ADDENDUM TO INVITATION TO BID

PROJECT: **BID #D00424 – STAUNTON CROSSING – ELEVATED WATER STORAGE TANK**

DATE: **MAY 9, 2024**

ADDENDUM: **1**

NOTE:
FENCE POSTS, SUPPORTS,
AND FABRIC SHALL BE
BLACK PVC CLAD

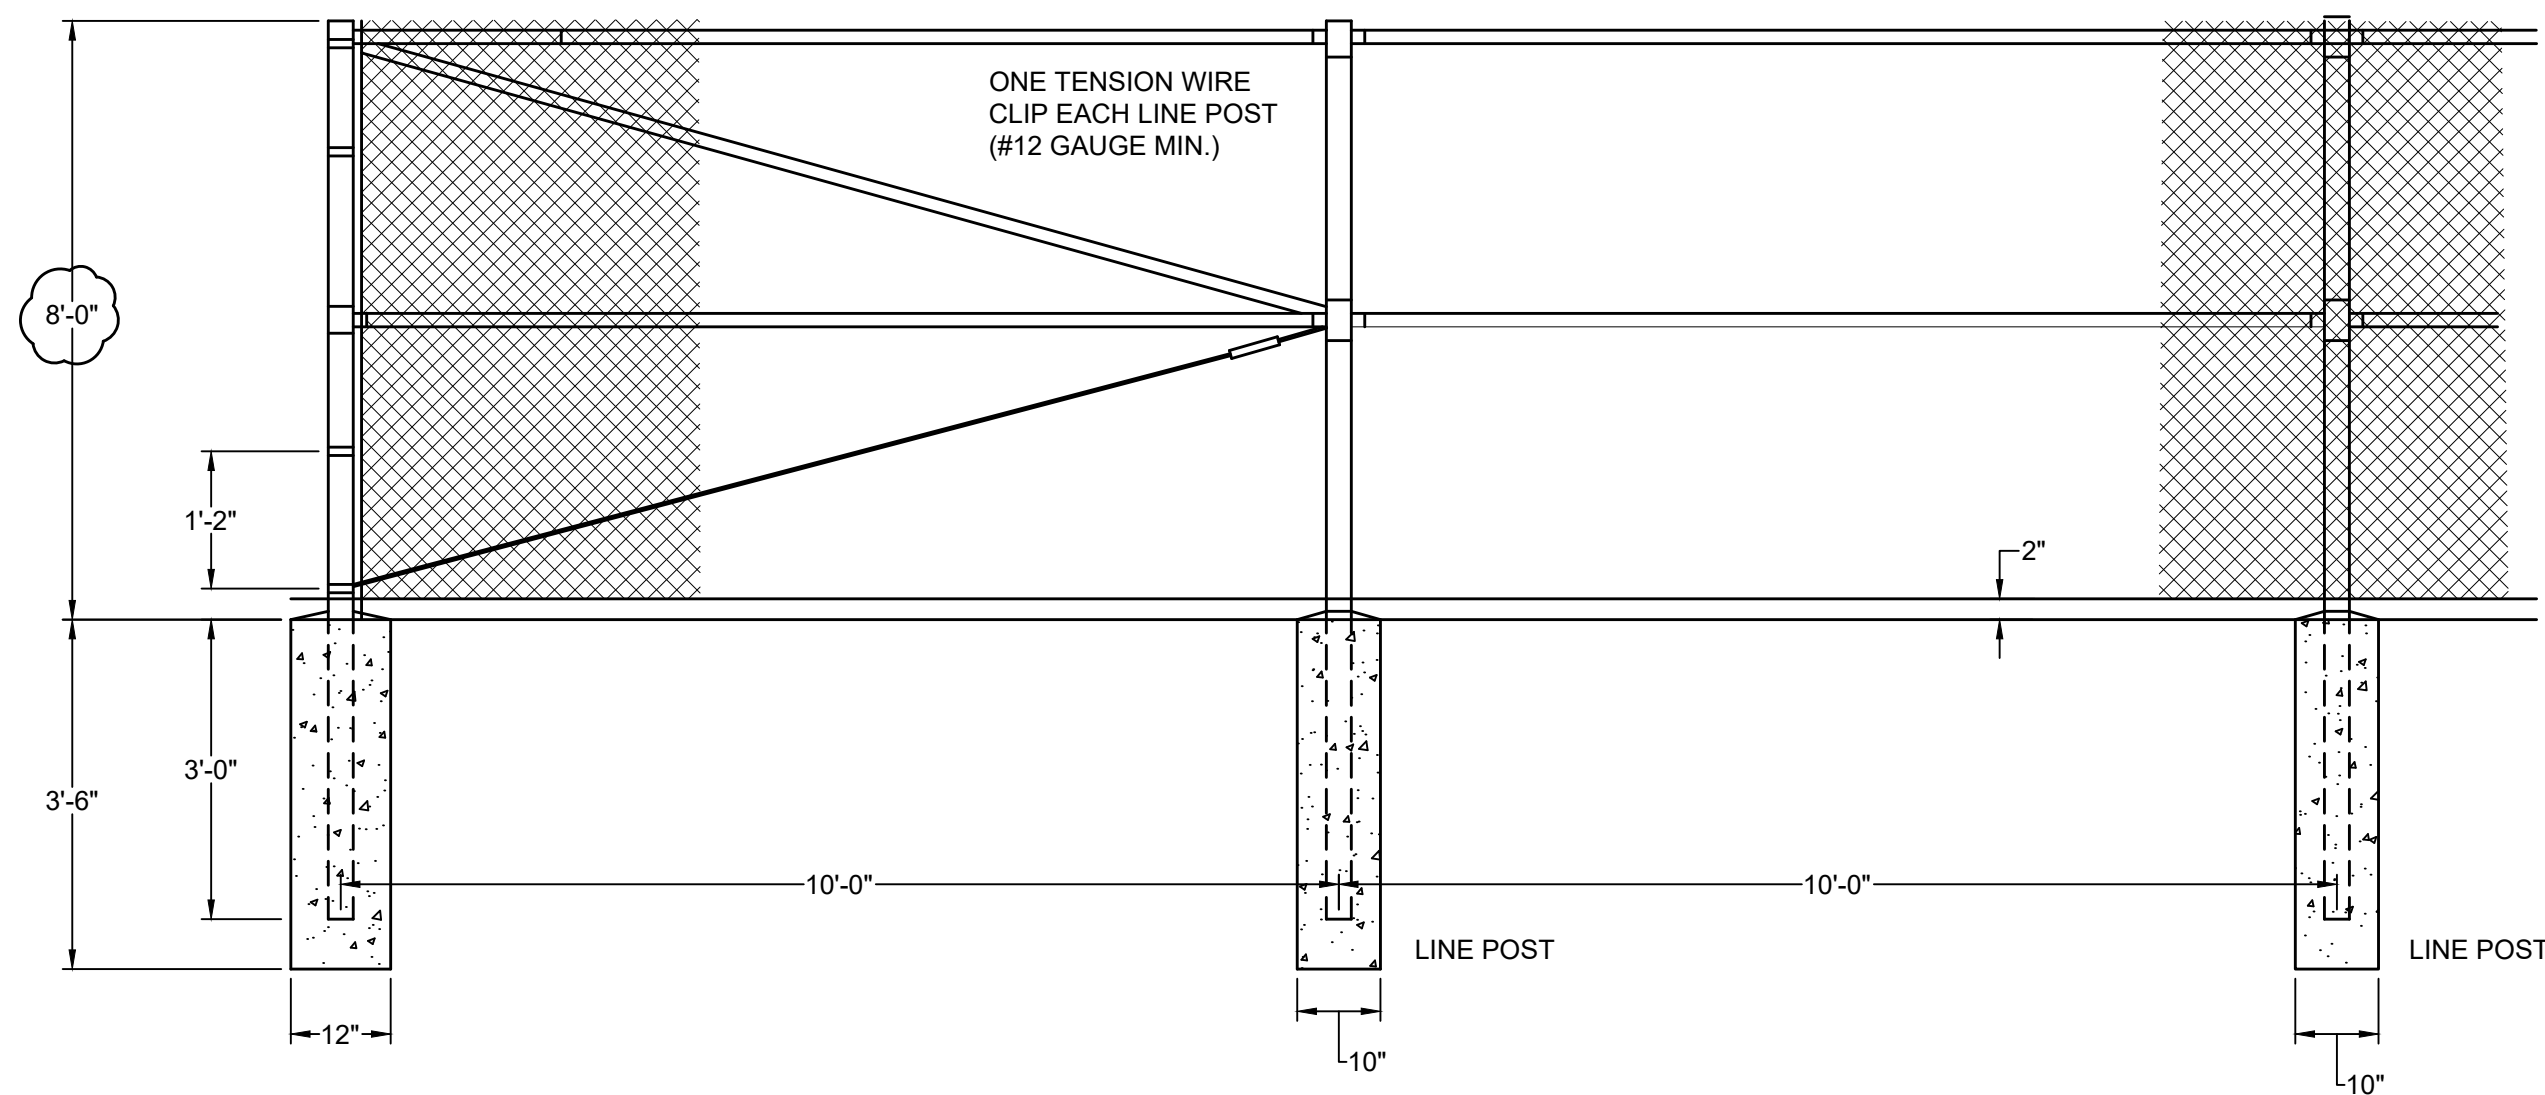
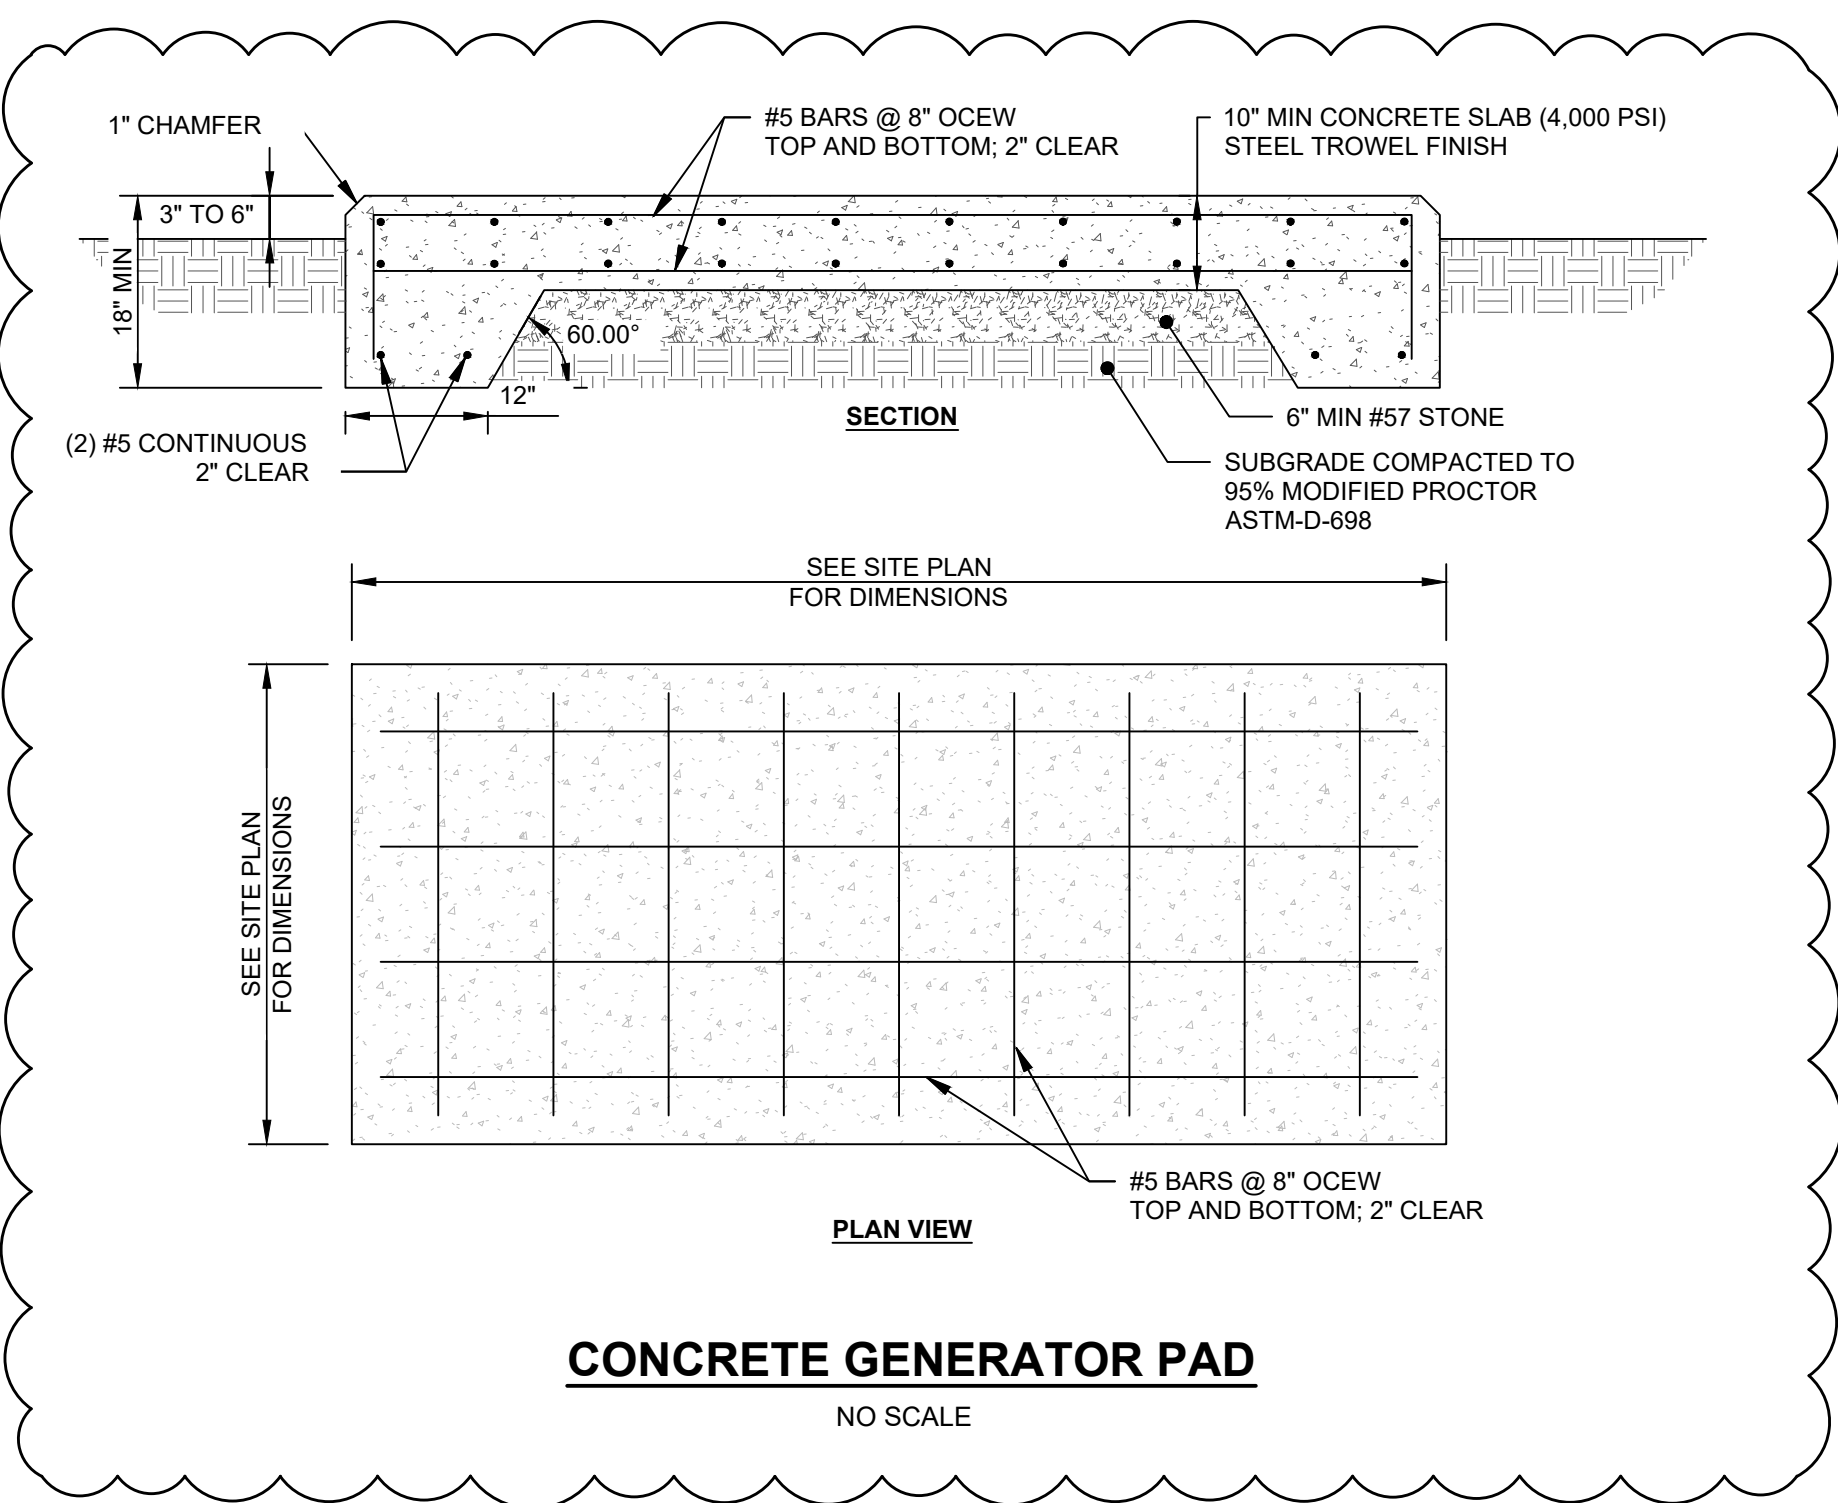
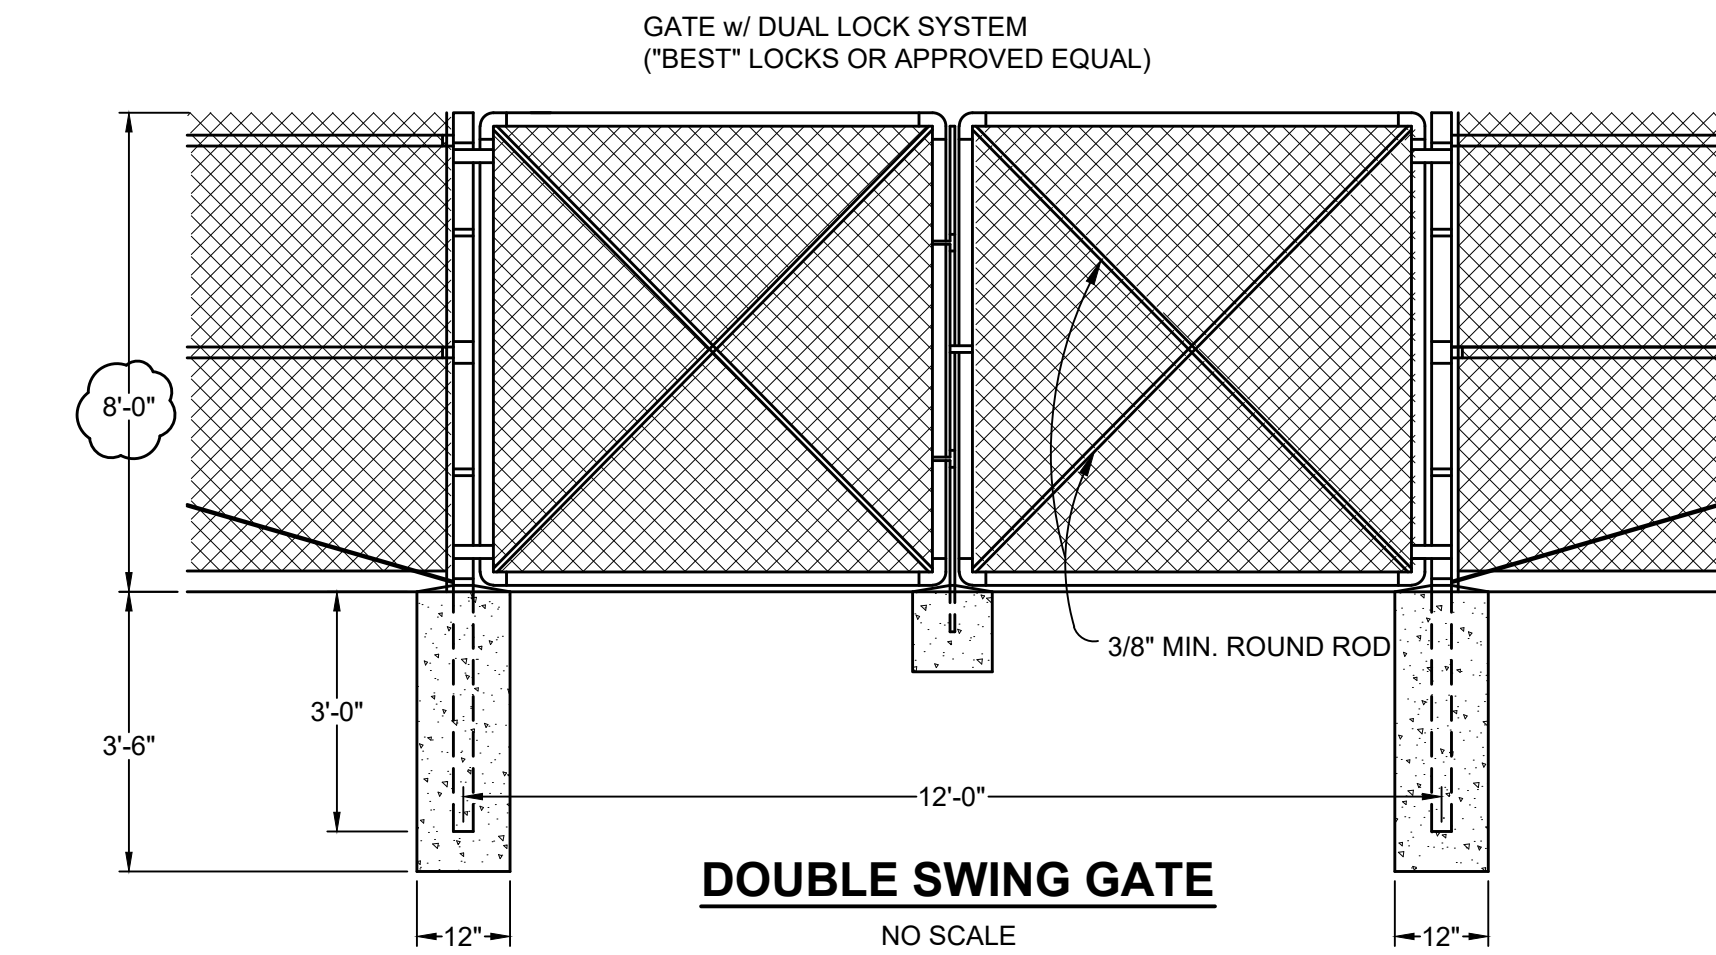
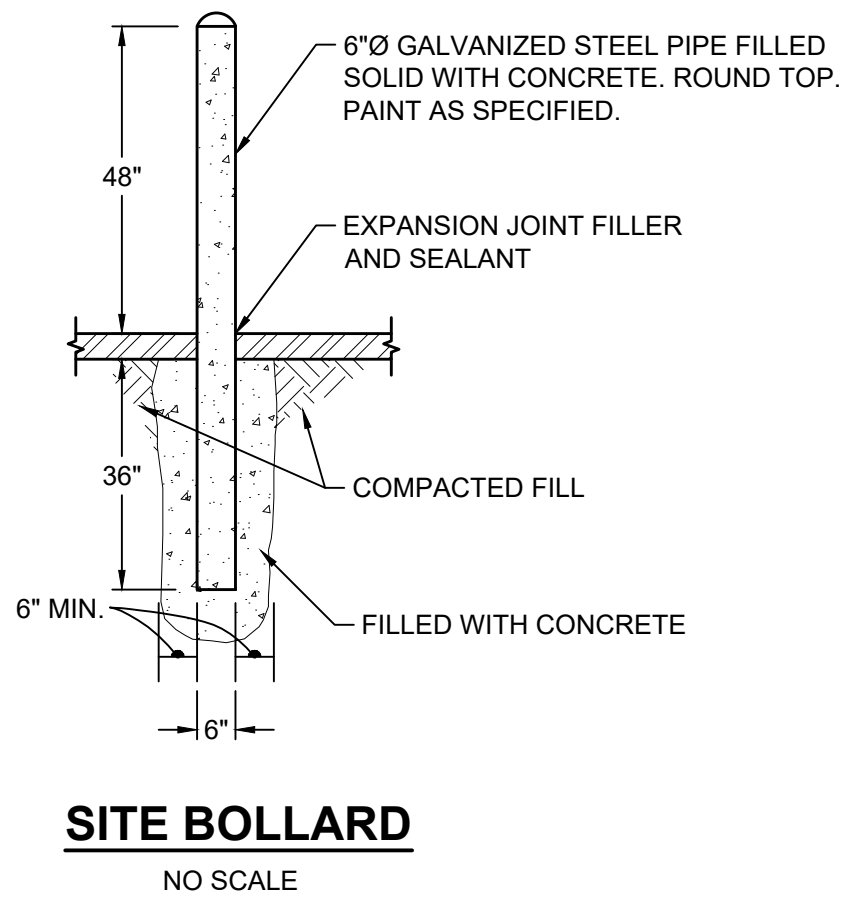
6. Is there any design for the retaining walls?

18. Item 1.3 D discusses the Anniversary Inspection. Please verify that the Owner will supply the water for the re-filling of the tank after the inspection.

45. Sheet T1.0 – Plan notes indicate an 8'-0" security perimeter fence is shown to be installed. Sheet T2.0 Fence details indicate a 6'-0" perimeter fence is to be installed. Can you confirm the security fence height is to be 6'-0"?

Response: Please refer to revised Drawings T1.0 and T2.0 for retaining wall details.

Response: Please refer to Concrete Generator Pad detail on Drawing T2.0.

Response: The security fence shall be 8'-0". Please refer to the updated detail on sheet T2.0
